TRUCKS
Nissan Diesel America, Inc.

VOLUNTARY SAFETY RECALL CAMPAIGN # 06V-462

RECALL BULLETIN 06V-462

VOLUNTARY SAFETY RECALL CAMPAIGN NUMBER 06V-462 : ALLISON TRANSMISSION SHIFT LEVER INSPECTION/REPLACEMENT

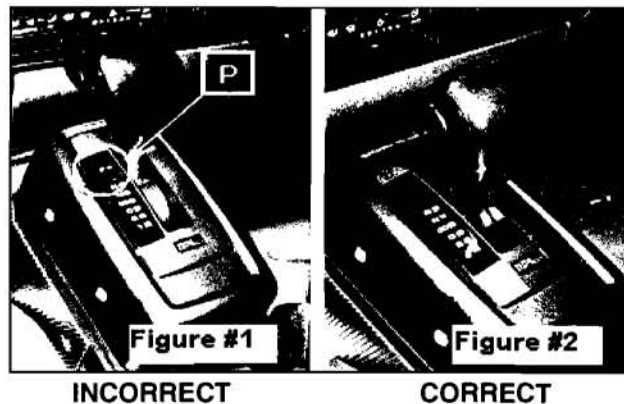
Nissan Diesel America, Inc. requests that you inspect your vehicle's Shift Lever Assembly for the "P" Park position as illustrated below. Your authorized UD Truck Dealer can also perform this inspection for you.

Figure #1 INCORRECT: Your vehicle will require the replacement of the Transmission Shift Lever Assembly. Please contact an authorized UD Truck Dealer as soon as possible to schedule an appointment to have the shift lever replaced at no charge to you. It is estimated that approximately 1.5 hours will be required to complete the repairs.

Figure #2 CORRECT: Your vehicle has the correct Transmission Shift Lever Assembly and no further action is required. Please complete the enclosed postage paid "AUTHORIZATION FOR RECALL SERVICE" card and return to Nissan Diesel America, Inc. Service Operations.

Figure 1 (Incorrect Lever) - With "P" Park position
Replacement of the shifter assembly is required.
Proceed with Step 2 of this bulletin.

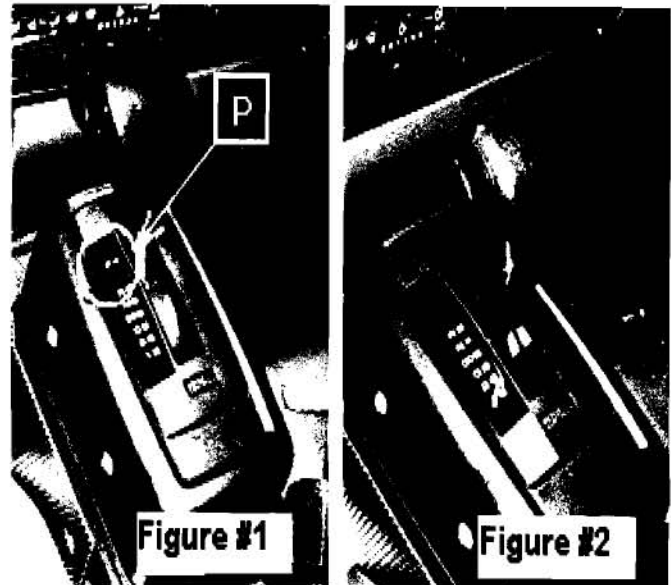
Inspect the Transmission Shift Lever Assembly and determine if a "P" Park position is present on the shifter and proceed as follows.

Figure 2 (Correct Lever) - Without "P" Park position
No further action is required.
Proceed with Step 4 on Page 5 of this bulletin.

STEP 2 - REPLACEMENT OF THE SHIFTER ASSEMBLY
